North Austin Medical Center PUD

C814-2008-0136.02 (PUD Amendment)

Watershed Protection

Planned Unit Development Amendment

OPTION 2 EXHIBIT

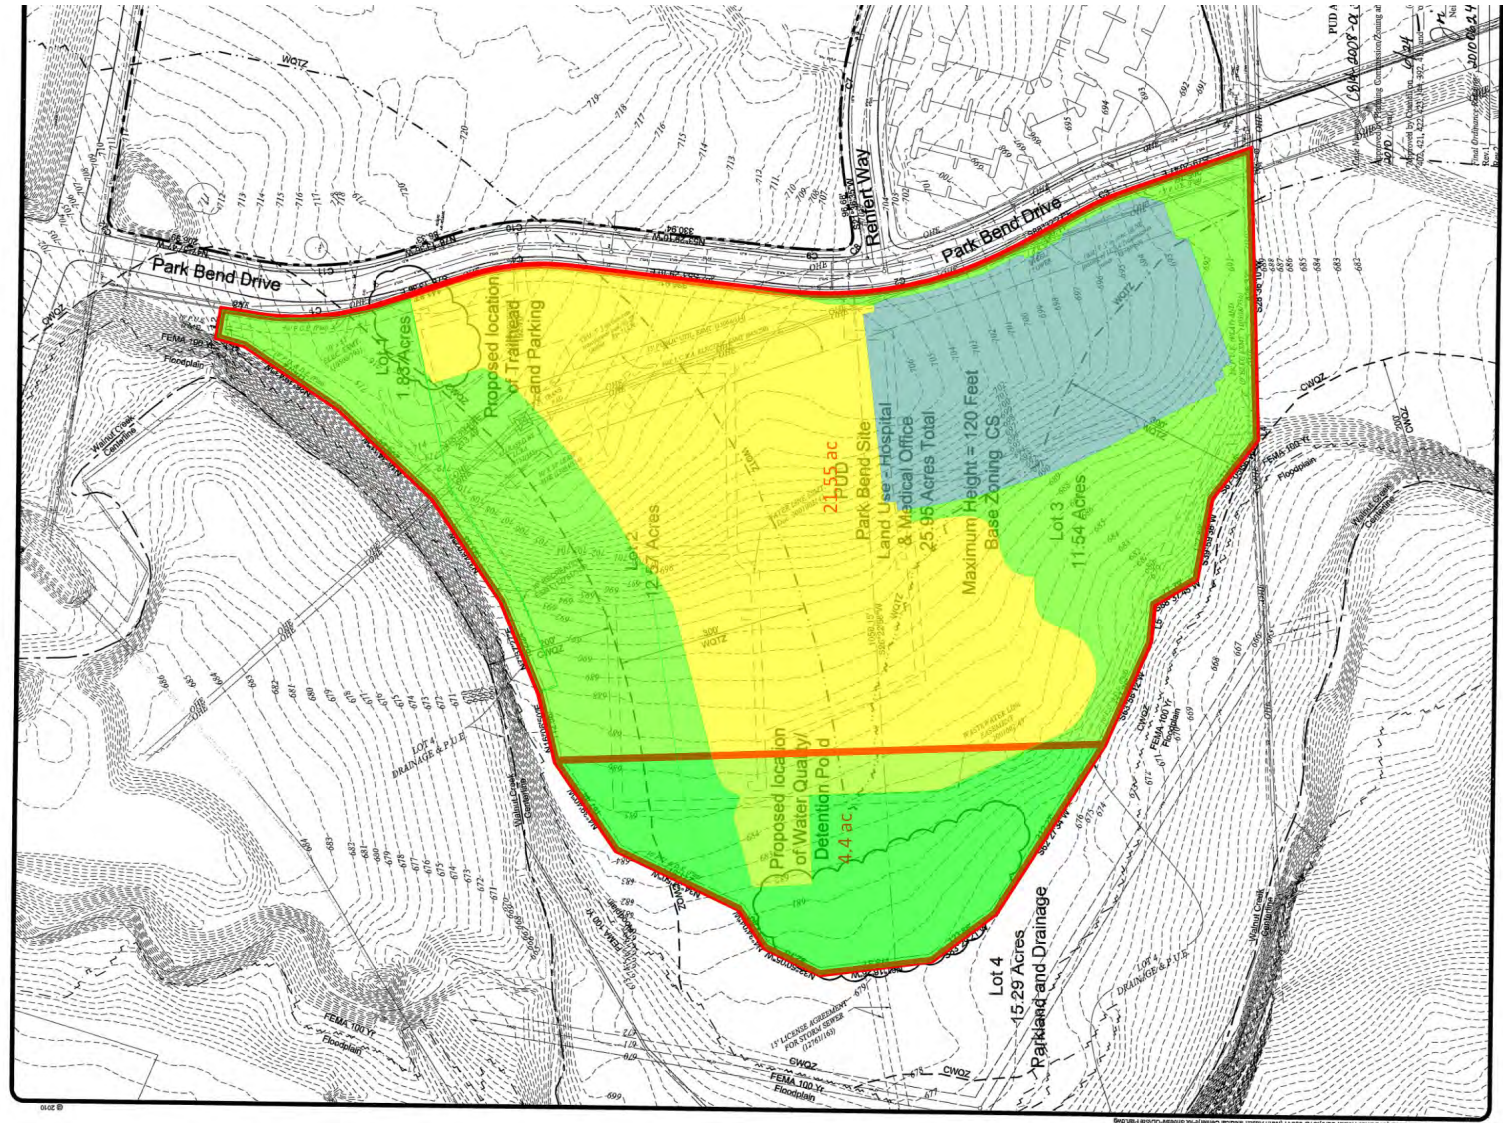
PUD REQUIREMENTS, PART 4.G
1. DRAINAGE AREA TO WATER QUALITY POND IS 13.65 ACRES INSTEAD OF THE REQUIRED 21.55 ACRES
2. THE PUD REQUIRES A WET POND WITH A SURFACE AREA OF 42,637 SF. NO WET POND IS PROPOSED.
3. THE PUD REQUIRES 4.5 ACRES OF VEGETATIVE FILTER STRIPS TO TREAT THE DRAINAGE AREA OF THE POND. INSTEAD, A WATER QUALITY POND IS PROPOSED, AND A GREATER AMOUNT OF TREES AND NATURAL GREEN SPACE IS MAINTAINED AS A BUFFER TO THE CREEK (ABOUT 8 ACRES).
4. THE PROPOSED WATER QUALITY POND WILL ACT AS THE WATER QUALITY BMP FOR THE SITE.

DETENTION POND TO BE REMOVED IN FAVOR OF EXISTING GREENSPACE AND TREES ACTING AS BUFFER TO STREAM AND EXISTING TRAIL

APPROXIMATELY 150 TREES WILL BE SAVED BY REMOVING THE WET POND REQUIREMENT FOR THE SITE. 17 TREES ARE CLASSIFIED EITHER AS PROTECTED OR HERITAGE

- 1. The project will provide water quality controls to treat all existing and new development proposed for the south tract (14.94 acres total) including a new biofiltration pond to treat 10.8 acres of that area.**

- 2. The proposed development will eliminate the removal of 111 trees, 20 protected size-class trees.**
- 3. This project will use alternative water sources to meet irrigation demands**
